Title: Advisory Committee on Nuclear Waste
142nd Meeting

Date: Thursday, May 29, 2003

RESPONSE TO ADVISORY COMMITTEE ON NUCLEAR WASTE COMMENTS ON THE YUCCA MOUNTAIN REVIEW PLAN (YMRP)

LICENSING PROCESS FIGURE

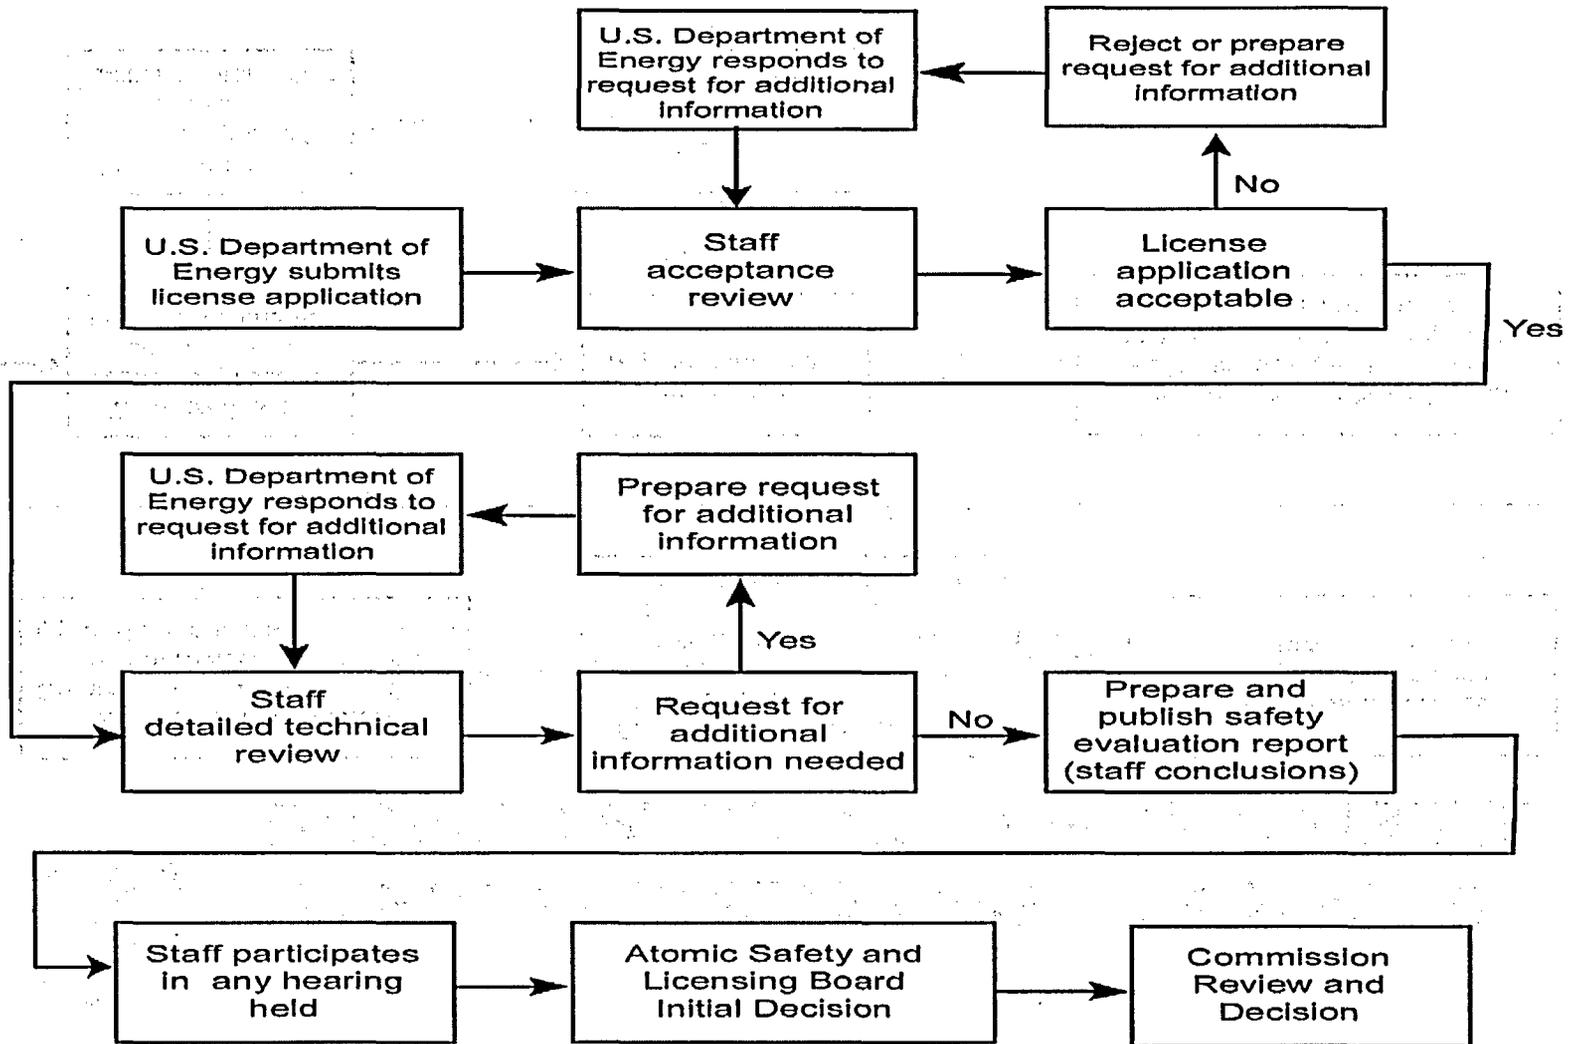
8 And, really, this box should be a triangle
9 because this is a decision point. I think there is
10 actually another block I need to add, and that's in
11 this case, that if there is a complete rejection of
12 the application because it is substantially incomplete
13 or if the staff defined that the license application
14 is sufficiently complete and a detailed technical
15 review could begin down here but additional
16 information is needed in limited areas. That kind of
17 gets you into this loop here.

24 VICE-CHAIRMAN GARRICK: Jeff, I agree with
25 your comment earlier that if you change the shape of

1 some of these blocks, some of the typical logic
2 shapes, such as a diamond for decisions and what have
3 you, that it would improve it a little.

4 Is there any chance that on the critical
5 blocks, you could indicate a range of time that is
6 involved in order to telegraph the fact that some of
7 these boxes happen, take hours, and some of them take
8 months?

9 MR. CIOCCO: Certainly, yes, yes. And
10 that's a good point. For instance, the acceptance
11 review is a 90-day --

18 MR. CIOCCO: Yes. Actually 18 months to
19 get to the staff's safety evaluation report and then
20 3 years with an optional fourth year to get to the
21 final decision.

HYPOTHETICAL REVIEW OF A TYPICAL LICENSE APPLICATION SECTION FIGURE

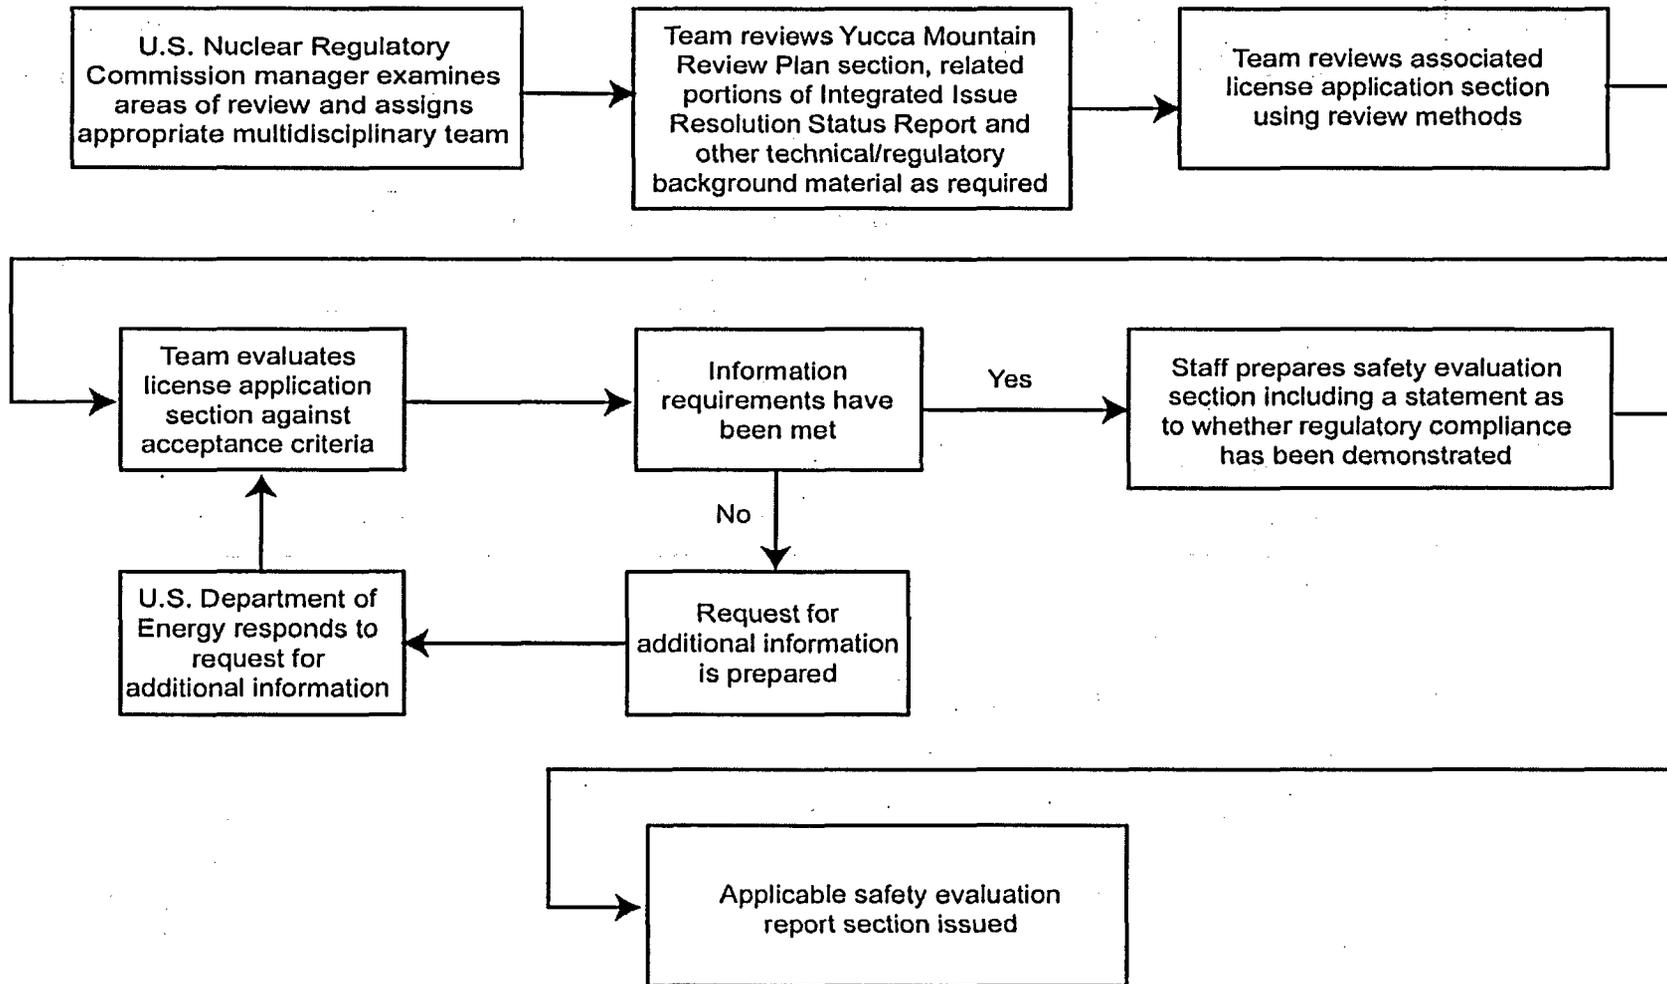
21 In response to your second comment that we
22 add an example, we are going to take this down into
23 even further detail.

11 So this one just gets down into a little
12 bit more detail where the project manager is actually
13 getting together the appropriate staff, NRC staff and
14 contractors, with the appropriate disciplines. So
15 those are the two figures we added in response to your
16 comments to really aid the reviewers and others in
17 using the Yucca Mountain review plan.
